132-134 CHURCH ST HAWTHORN: EXPERT URBAN DESIGN EVIDENCE

## PROPOSED APARTMENT BUILDING 132-134 CHURCH STREET HAWTHORN

## EXPERT URBAN DESIGN EVIDENCE

VCAT reference no.:P1069/2014Evidence by:Nathan AlexDate of report:September 1Property address:132 and 134Inspected:5th and 13thPrepared for:City of BoroInstructed by:Mr AndrewCity of Boro

Figure 11: Eastern elevation of the proposed development

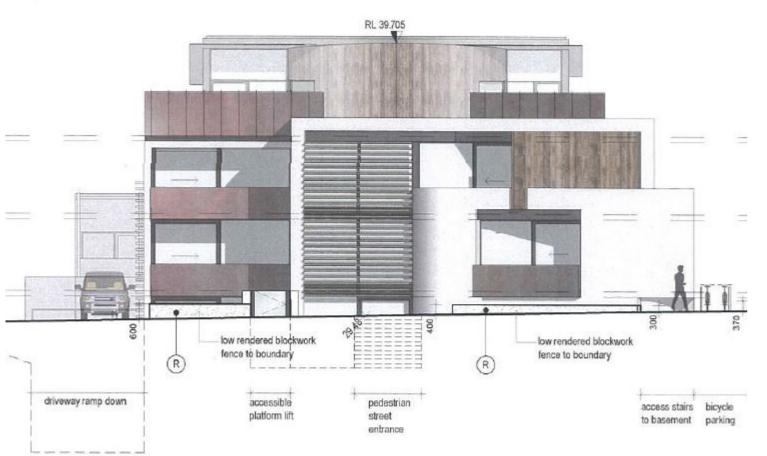
- [70] The building is a complex form and generally steps back on all sides. Exceptions are the southern part of the east facade, which rises vertically over the ground floor and next two levels, then steps back approximately 1 m at the penthouse, and the south facade above the driveway, which rises vertically for three floors.
- The roof appears to be a plane falling [71] evenly to the west, with a protrusion for the lift overrun and another for the mechanical plant. The lift overrun is dimensioned and would not be visible from Church Street, and probably not from most if not all public and private viewpoints within a kilometer or more. The mechanical plant screening is not dimensioned and is only shown on the roof plan. It seems to be recessed, but this is not clear to me.

- [106] In this instance being a storey higher than any other building clearly makes the proposed building out of character in this regard, but not necessarily disrepectful of the neighbourhood character. I have carefully considered the plans and elevations of the amended proposal, and the perspectives of the original proposal, and consider the fourth floor would be noticable without being visually dominant, except perhaps when travelling south along Church Street. By itself I do not consider the fourth floor as shown to be disrespectful of the neighbourhood character.

Figure 13: Plan of the basement level of the proposed development

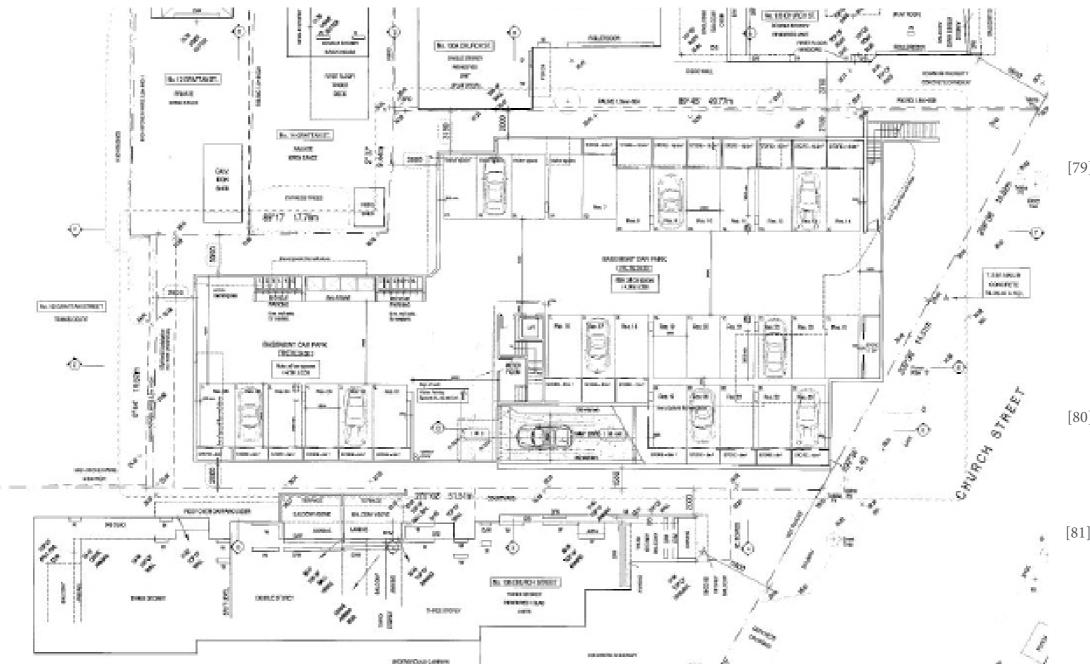
The basement is built to the Church [76] Street boundary at two points. It is set back from the north boundary 2.0 m or more, from the west 2.9 m or more, and from the south 1.55 m on the east end and 2.0 m on the west end. The basement is below existing ground level at the north-east corner approximately 1.5 m, while in the south-west corner it is elevated approximately 1.0 m.

- [87] The extent of the basement will limit the soil depth available for plant growth in the front garden. This would be especially limiting in the southernmost green space, between the platform lift and the driveway, where the basement would be underneath almost all of it. The basement would be under only a small proportion of the northern front garden space, and so growing one large tree would be possible there, perhaps even a small group.

Figure 14: Eastern part of the ground floor plan, showing the front yard

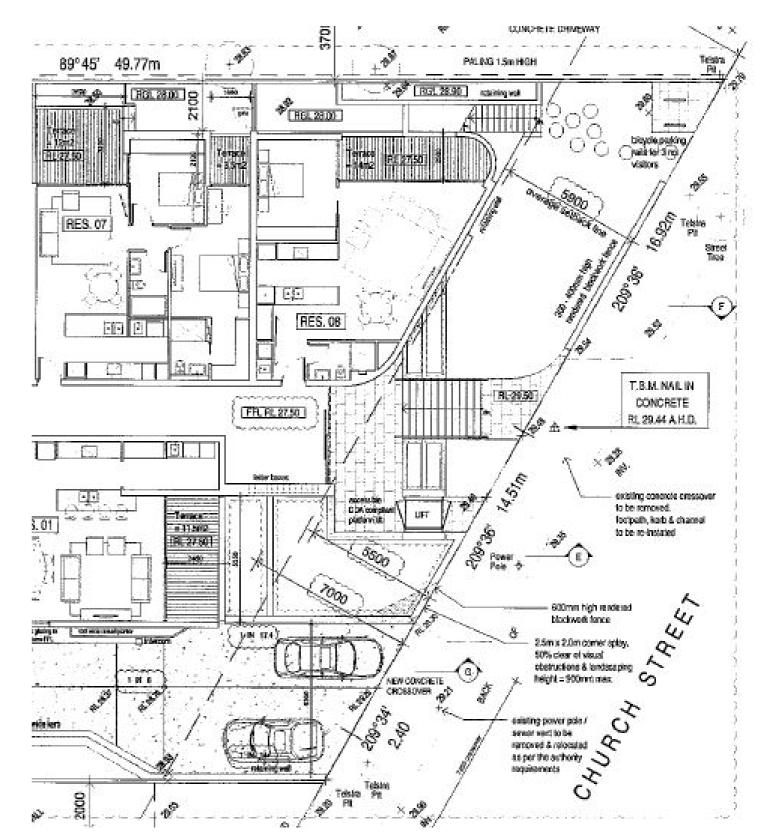
- [86] The latest architectural plans show a front wall on the street boundary of very low rendered blockwork. Side and rear boundary walls are also rendered blockwork. They run on both the north and south boundaries at a height of approximately RL 30.0 to a little west of the lift, then step down the slope, generally maintaining a 2000 mm height above the proposed ground level. This leads the wall to be up to 2860 mm above natural ground level in places.

- [88] The driveway is hard against the southern boundary for approximately 6 m from the street, precluding the opportunity for any planting in the front yard for the width of the drive and abutting walls, approximately 6.5 m.

- The private open spaces of Res. 02, 06, [90] 07 and 08 include strips of ground that are less than 2100 mm wide. Res. 03, 04 and 05 have access to strips of ground less than 2100 mm wide, but also some west-facing strips 2900 mm wide or so.

Figure 15: Detail of the ground floor plan showing the southern setback of the building

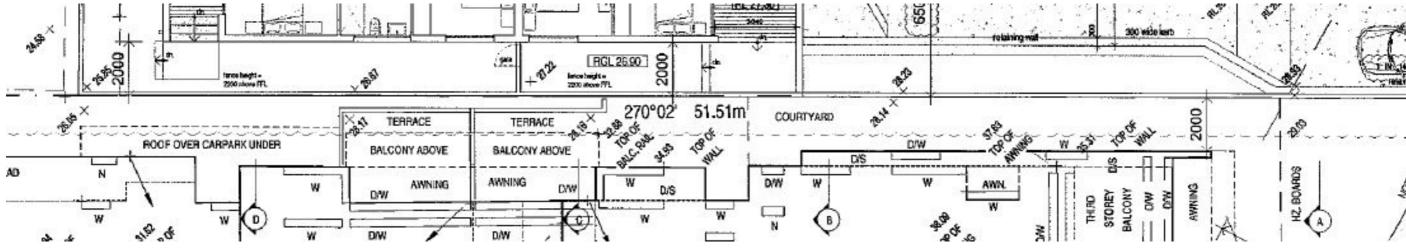
- [109] The proposed development does respect the existing street setback in distance, but not in the pattern of facades facing east rather than aligning with the street.
- [110] Does the proposed development provide approriate landscaping to reflect the garden character of the area?
- [111] The proposed development allows the opportunity for sufficient soil mass, surface aeration, light and space in the north front yard to grow a substantial canopy tree. However such opportunities do not seem likely on the south side of the front yard, nor in the very constrained side and rear yards.
- [112] The east-west garden strips, 2100 mm wide or less, provide enough space between the external wall of the building and the boundary fence to squeeze past

- a substantial tree trunk, but it would be an uncomfortable relationship. It is also unlikely that trees would be planted in these locations, because when young, the lower branches are likely to block passage, and when older the trees would reduce light to any planting underneath and the people living in the floors above are unlikely to like trees restricting their views and light.

- [113] I have identified thirteen locations in corners where planting of trees would be more suitable, but I regard these locations as unlikely to host canopy trees. This is especially so on the southern side, where light will be at a premium.

- [114] My experience as an urban designer and landscape architect is that in the conflict between screening a building with vegetation and allowing in light and views to those living in the building, the people usually win over the vegetation. This may be from deliberate removal or from neglect. I certainly cannot see the residents of Res. 04 and 05 maintaining all of the dense rows of Lilly Pillies on their north and west walls. Although they would be excellent heat shields in summer, they would block much of the potential daylight to the apartment interiors.
